New Bedford Harbor Superfund Site Community Forum

EPA Responses to Concerns Listed by the  
of Acushnet and Fairhaven

November 29, 1995

# Location of Cross-section Views for CDF 1B

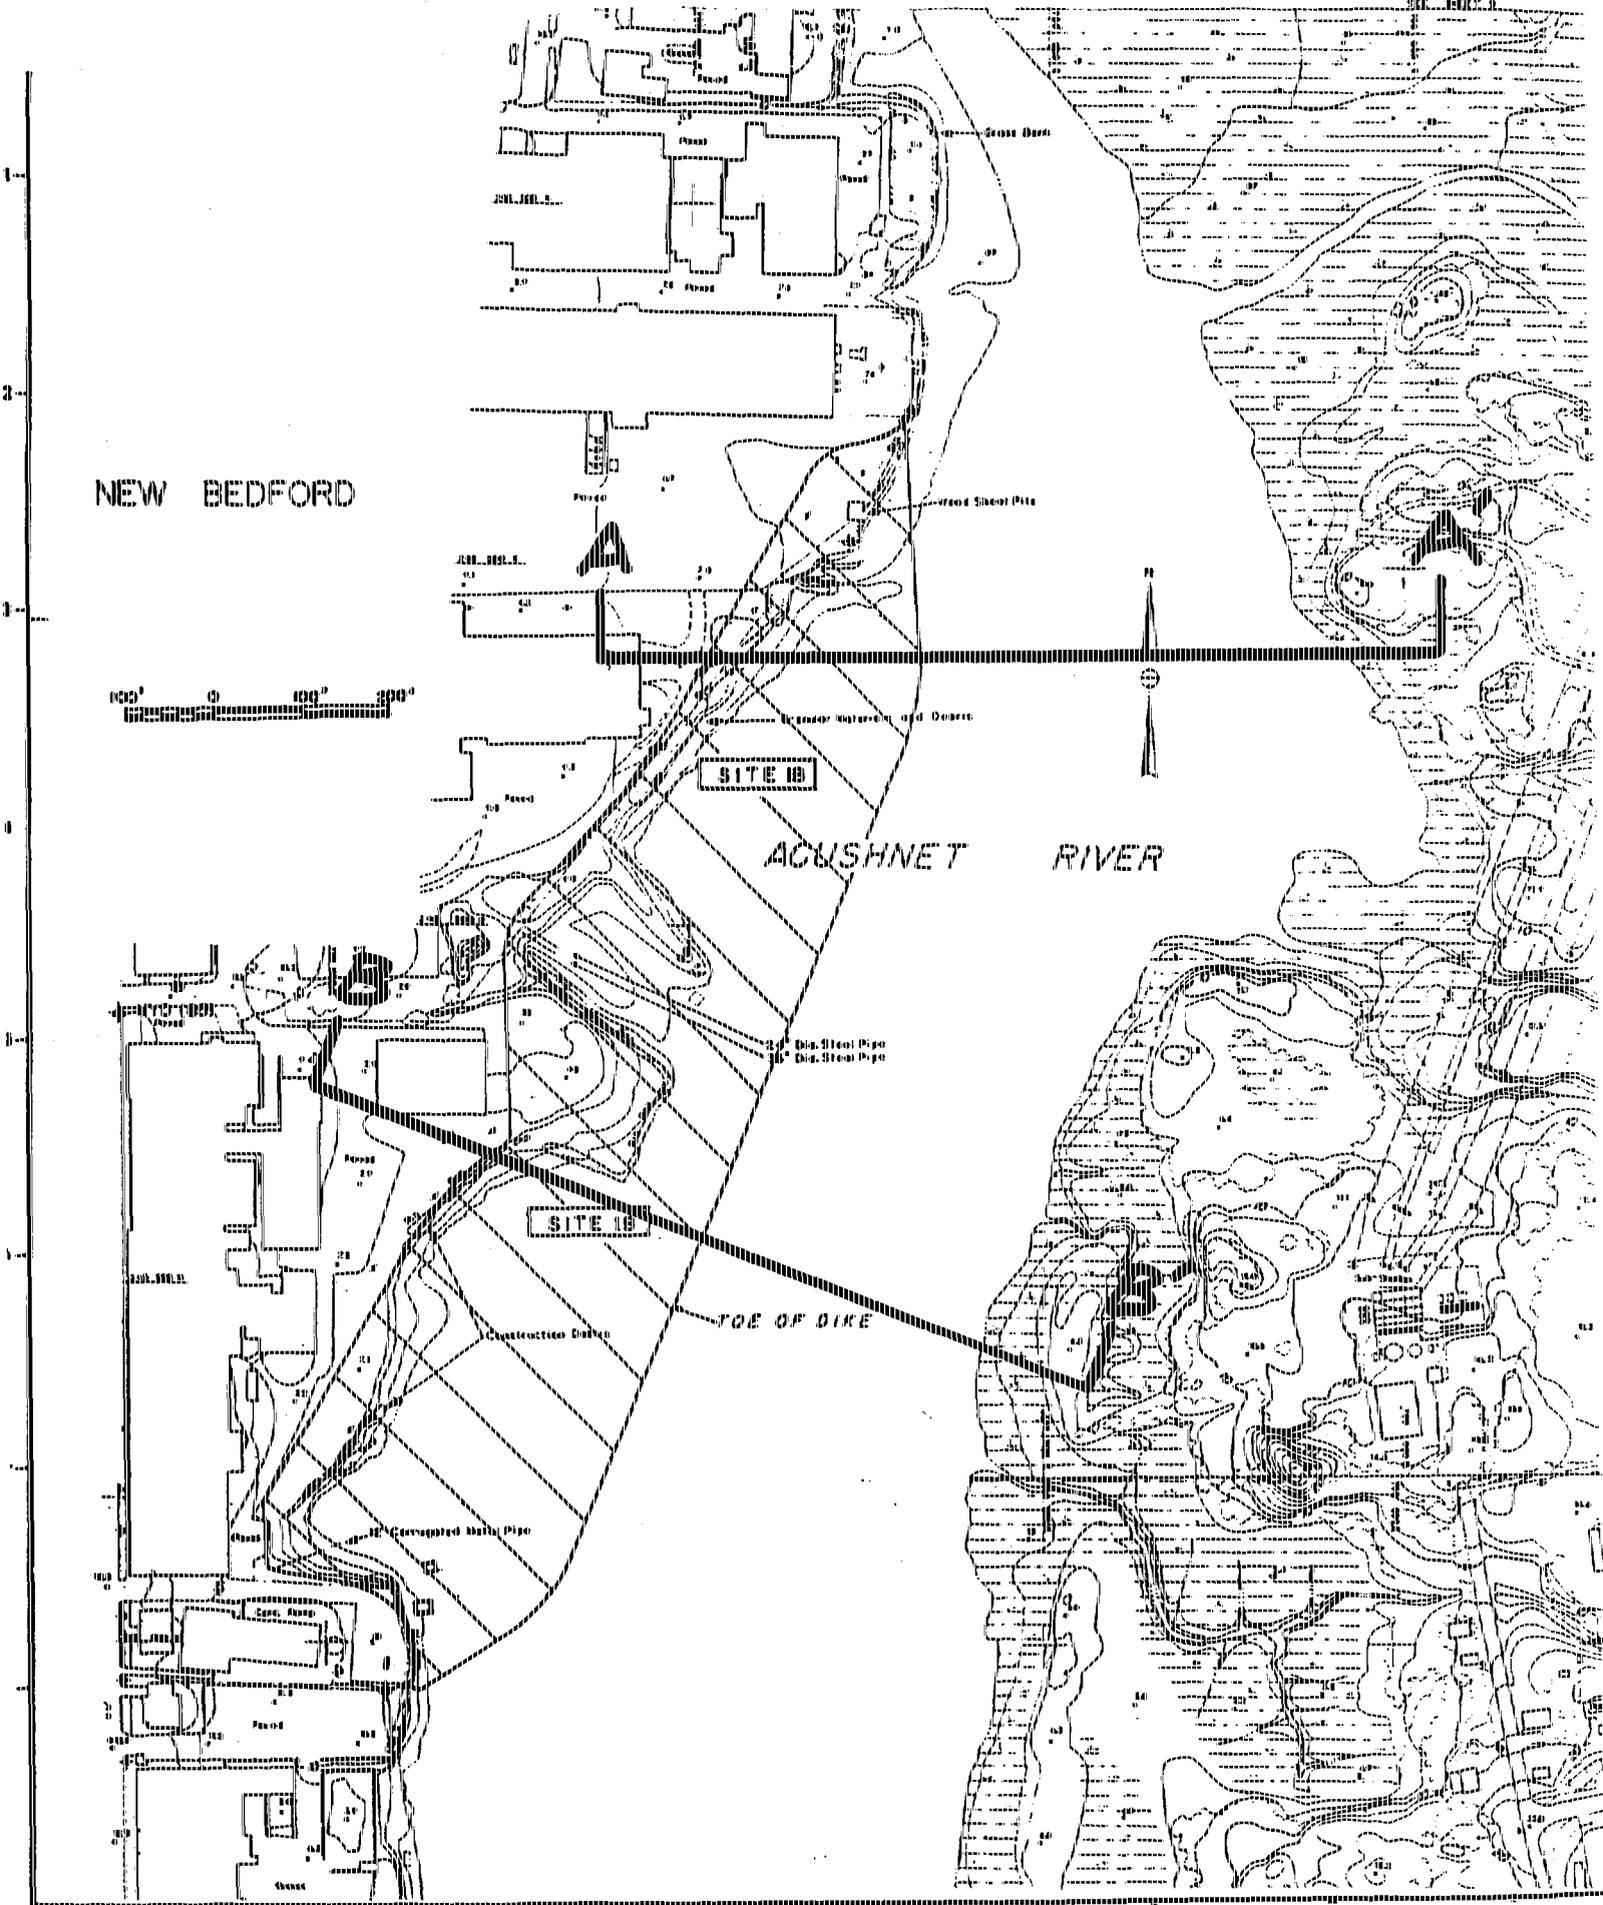
2. *According to the EPA's map and explanation CDF 1B will be approximately 1700 feet long and 200 to 400 feet wide stretching into the river behind the Aerovox Corp. This means that there is*

a strong chance that we the citizens of Acushnet will be looking at a wall 8 feet above high tide which will look like another hurricane dike. We are also concerned that once these CDF's are built that Acushnet will loose (sic) a number of important footage of our wet lands which have been the homes and breeding grounds of hundreds of rear (sic) water fowl which have returned to our shores in the (last) several years. Could you please give us the scientific study that shows the displacement of the water levels to the Acushnet banks of the river? And the overall impact to the wildlife and natural beauty that we have been working for during this clean up?

The second set of calculations was done just recently in response to the concerns voiced by Acushnet in this regard. This preliminary assessment considered the cross-sectional areas of river flow at two different points along CDF 1B (see the attached map), using conditions of both before and after CDF construction. The poster-size illustrations of these two cross-sections

developed for the Forum was used to calculate the various areas within the cross-sections. The purpose of this effort was to compare the cross-sectional area or vertical plane (measured in square feet) through which the river water now flows to the cross-sectional area through which it will flow after the river is dredged and the CDF constructed.

The two transect locations were used since the cross-sectional areas within the river change as the shorelines weave in and out. In addition, the cross-sectional areas were calculated using both high and low tide conditions, so that a total of eight cross-sectional areas were calculated (two cross-sections, high and low tide, before and after CDF 1B). The underlying premise is that if the cross-sectional areas after the CDF is constructed are greater than or equal to the areas before CDF construction, then the river flow will not be "choked off" or diverted, and the overall tidal levels in the harbor will determine the water level in the wetlands. In other words, if the CDF were to inhibit the flow of water, it is assumed that the water would tend to "flood" the low-lying wetlands. This is a conservative approach since even if the cross-sectional areas were lower after construction, the water could move at a faster velocity through that area in order to move the same amount of water through. (One local example of this process is at the severe constrictions at the Coggeshall Street and Route 195 bridges.)

These calculations indicate that the cross-sectional areas after CDF 1B construction will typically be GREATER than before construction. This is due to the fact that 2 feet of sediment will be removed during the remedial dredging operations. Given the underlying premise of the analysis, this indicates that the water levels will NOT be impacted by the CDFs. The results are summarized below:

Before CDF 1B	After CDF 1B
Section A-A' at high tide	3401 ft <sup>2</sup>	3706 ft <sup>2</sup>
Section A-A' at low tide	361 ft <sup>2</sup>	1326 ft <sup>2</sup>
Section B-B' at high tide	3225 ft <sup>2</sup>	3011 ft <sup>2</sup>
Section B-B' at low tide	478 ft <sup>2</sup>	1237 ft <sup>2</sup>

The one set of conditions where the area after CDF construction is slightly lower than before construction is for the high tide condition at section B-B'. Three issues need to be noted in conjunction with this to illustrate why impacts are not expected in the wetlands. First, as brought up at the recent Sea Change expert panel session, the "topography" of the river bottom will be more elliptical in nature after dredging (see the cross-section poster), which will allow for greater flow than the flat-like topography before dredging - due to less "friction loss". Second, the wide disparity for the low tide numbers for section

B-B' (478 ft<sup>2</sup> versus 1237 ft<sup>2</sup> ) indicate that only at peak high tide will the before and after areas be similar. Third, as mentioned above, the conservative nature of this approach adds additional factors of safety to the analysis (again, think of the Coggeshall Street and Route 195 bridges).
